Access Compliance Report Public Rights-of-Way (Curb Ramps)

Intersection ID: 10019976 Main Street: ARENA_BV Cross Street: N/A Location: SE

ADA ID: BDCE3DA8F3C4 Ramp Type: PerpDiag Initial Pass/Fail: Fail Overall Compliance: No Severity Score: 13.75

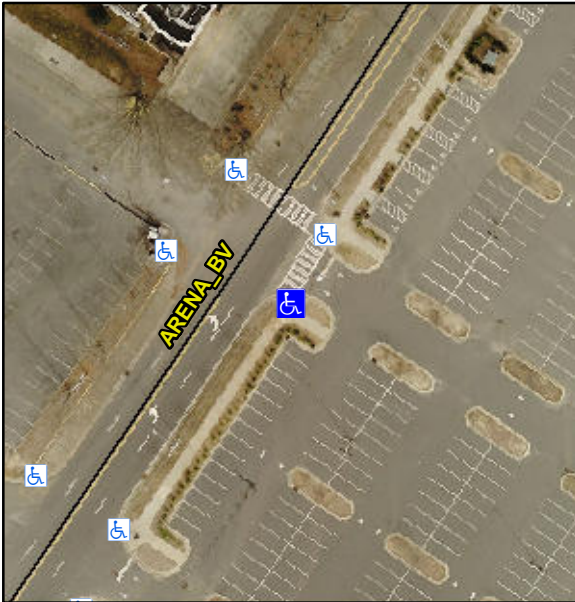
Not Found, R304.2.2, R304.5.3

Compliance	Description	Data	Compliance	Description	Data
N/A	Ramp Length (in)	96.0	No	Ramp Slope (%)	9.6
Yes	Ramp Width (in)	61.0	No	Ramp XSlope (%)	2.9
N/A	Flare Type LT	N/A	N/A	Flare Type RT	N/A
N/A	Flare Slope LT (%)	N/A	N/A	Flare Slope RT (%)	N/A
N/A	Flare Traversable LT?	N/A	N/A	Flare Traversable RT?	N/A
N/A	Landing Length (in)	N/A	N/A	DWS Provided?	N/A
N/A	Landing Width (in)	N/A	N/A	DWS Contrast?	N/A
N/A	Landing Slope (%)	N/A	N/A	DWS Length (in)	N/A
N/A	Landing X Slope (%)	N/A	N/A	DWS Full Width?	N/A
N/A	Landing Curb? (Y/N)	N/A	N/A	DWS Offset (in)	N/A
N/A	Shared Landing?	N/A			
N/A	Gutter Ponding?	N/A	N/A	Gutter Slope (%)	N/A
N/A	Gutter Lip Ht (in)	N/A	N/A	Gutter X Slope (%)	N/A
N/A	Painted X Walk1?	Yes	N/A	Painted X Walk2?	No
	X Walk 1 Direction	To NE		X Walk 2 Direction	To NW
N/A	X Walk 1 Width (in)	112.0	N/A	X Walk 2 Width (in)	N/A
	X Walk 1 Slope (%)	1.5		X Walk 2 Slope (%)	2.4
	X Walk 1 X Slope (%)	4.5		X Walk 2 X Slope (%)	0.8

Possible Solutions:
Remove & Replace Curb Ramp With Two New Directional Ramps or Equivalent.
